1. **Service Letter No.:** SL46 66-12102-3
2. **Subject:** Fuselage Fittings
3. **Part/Assembly No.:** 66-12102-3
4. **Float Model Affected:** 6650 and 6750
5. **Compliance:** **Mandatory** **Recommended** **Optional**
6. **Approval:** All information provided is in accordance with approved data.
7. **Corrective Action:** Non-required.
8. **Time Required:** 2 hours per side plus 1 hour per each hold drilled (4 to 6 hours total depending on need to drill holes in strut).
9. **Payments:** Credit to Customer Under Warranty Customer Pays

DESCRIPTION of CHANGE:

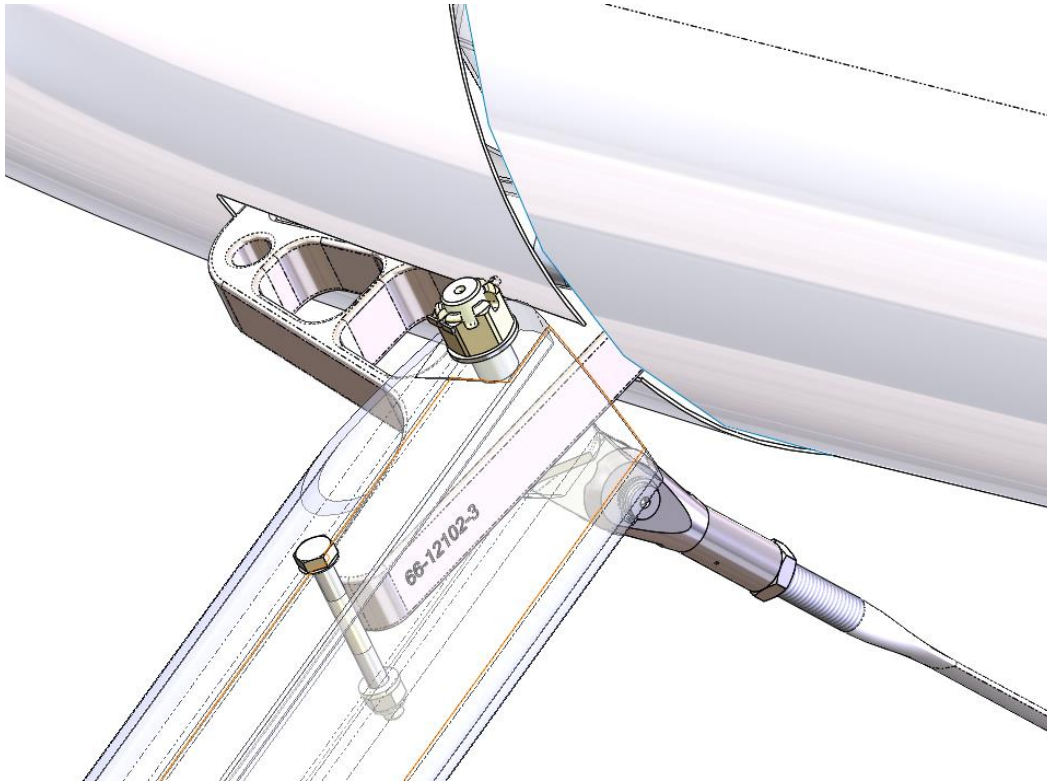
In order to reduce the chances of environmental hydrogen embrittlement particularly in marine environments, Aerocet has changed the 66-12102-2 fitting to 66-12102-3, having a different heat treatment.

The above image shows a 66-12102-3 fitting with the engraved number on the aft-lower arm of the fitting. (FWD strut is transparent; view is aft-quartering, LHS, looking forward and inboard) (Note that the “-2” fitting is similar, but lacking the engraved number.)

For 66-12102-2 replacement, exchange the -2 with a -3. Inspect and re-use or replace hardware as necessary.
